CITY COUNCIL STAFF REPORT
Meeting Date November 10, 2025

REPORT TO: Michael Sable, City Manager
REPORT FROM: Elizabeth Hammond, Planner
PRESENTER: Danette Parr, Community Development Director
AGENDA ITEM: Design Review and Parking Waiver Resolution, Seven Brews Coffee, 2982 White Bear Avenue North

7 BREW COFFEE
 2982 WHITE BEAR AVENUE
 MAPLEWOOD, MN 55109

C5.1
 LANDSCAPE PLAN
 DATE: AUGUST 14, 2023

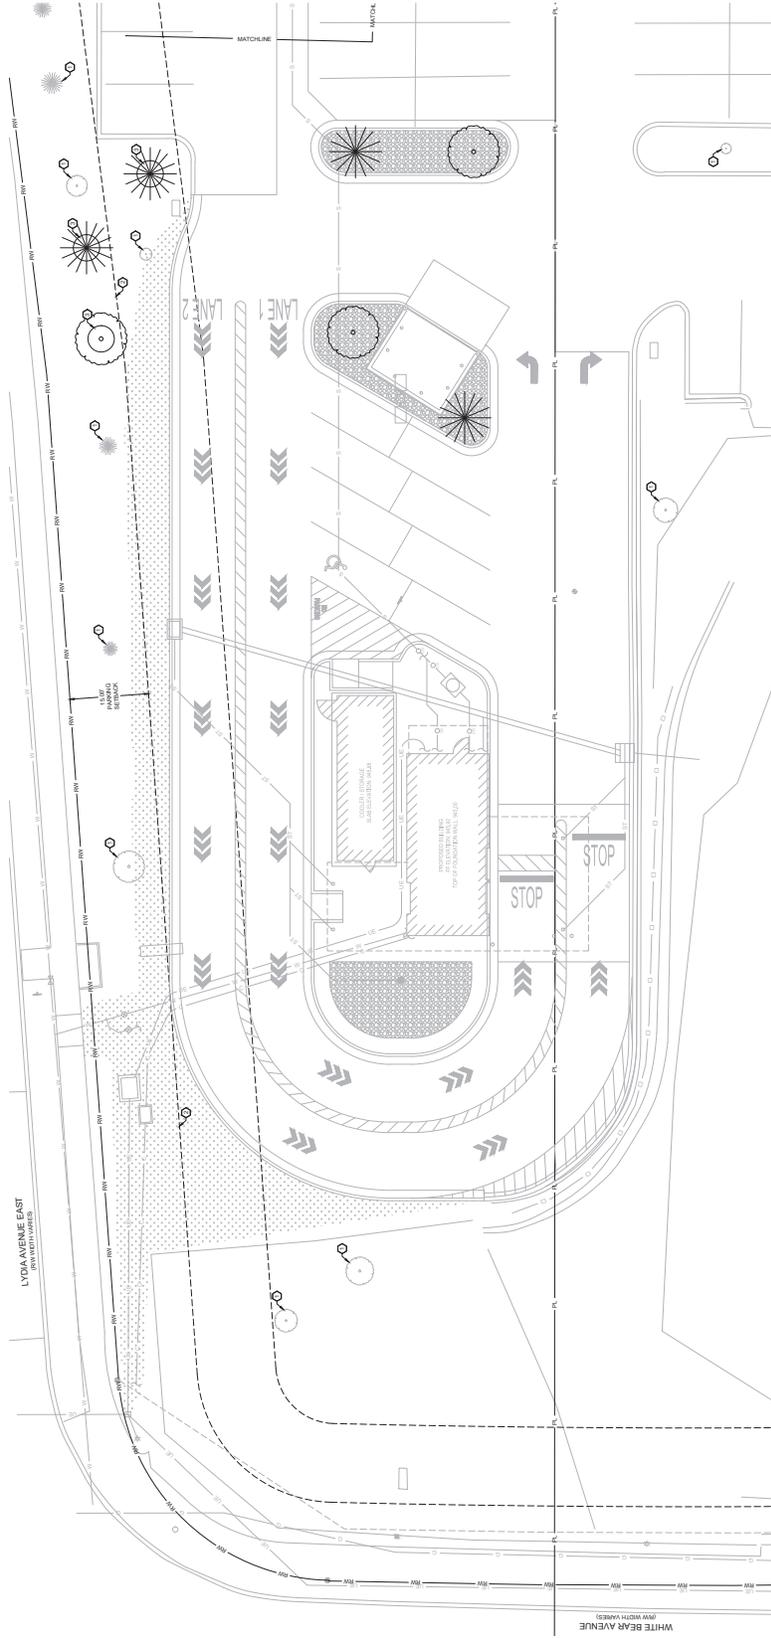
The proposed landscape plan shows that 13 trees would be removed, and six new trees would be planted. According to the environmental review, the applicant must submit a tree preservation plan and an updated landscape plan before a grading permit will be issued. Additional trees and landscaping should be installed throughout the site as part of the project.

- 1) A tree preservation plan that includes all significant specimen trees to be preserved, and calculations to determine the number of replacement trees required by the tree removal.
- 2) Revised landscape plan, detailing the location of seed and seed mix, and a three-year maintenance plan to ensure establishment. The revised landscape plan must replace non-native species with native or climate-resilient tree species, and bare-root trees with container trees. It should also include detailed tree planting instructions and preventative measures to ensure that invasive species are removed and not spread during construction.

- b. The applicant must provide a tree preservation plan and a revised landscape plan as outlined in the environmental review comments.
 - c. The canopy structure cannot extend over the property line. The applicant can prepare an easement for the encroachment, which must be provided to the city for review, or apply to adjust the south lot line so that the canopy does not encroach over the lot line.

EXTERIOR ELEVATIONS

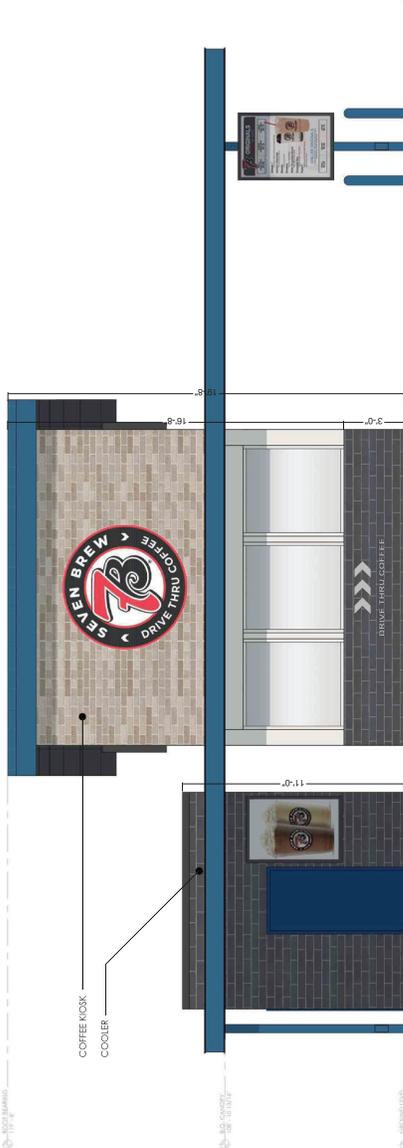
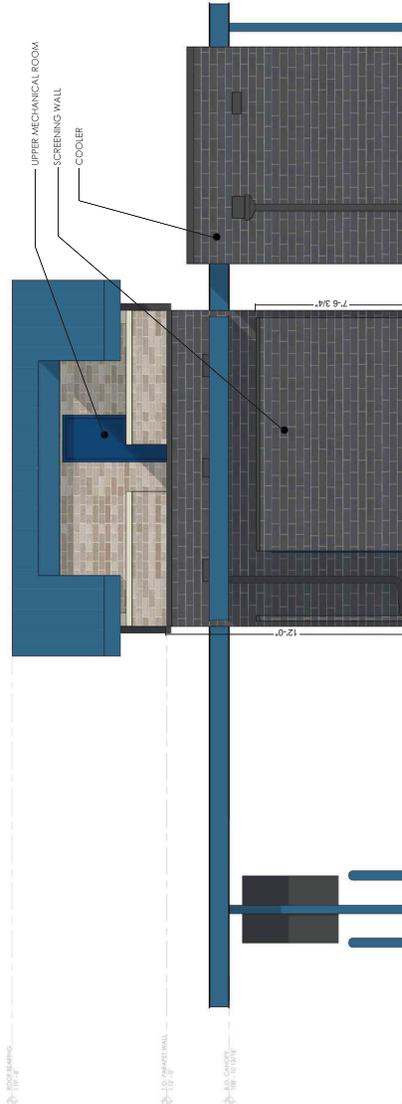
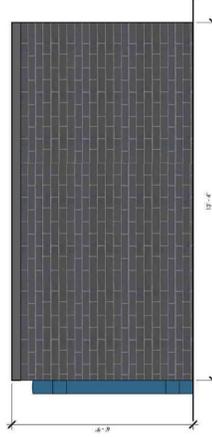
The elevations show wall signage for the business. However, any signage on the property is subject to review by the city and requires a separate permit for the installation of signs. All site signage must meet the city's sign code.

The applicant submitted a lighting plan; however, additional information is required for review. The lighting fixture sheets indicate that there are two types of exterior lights; however, there is insufficient information on the light specifications. The lighting plan must identify the type and location of all lighting. The elevations must show the area of any wall-mounted lighting. An updated lighting plan, which includes site and architectural plans, a detailed description of each luminaire, and a plan showing the light spread and footcandle levels, must be submitted to the city for review before a building permit can be issued.

- e. An updated lighting plan, including architectural plans, a detailed description of each luminaire, and a site plan showing the light spread at the property lines. The elevations must show the location of wall-mounted lighting.
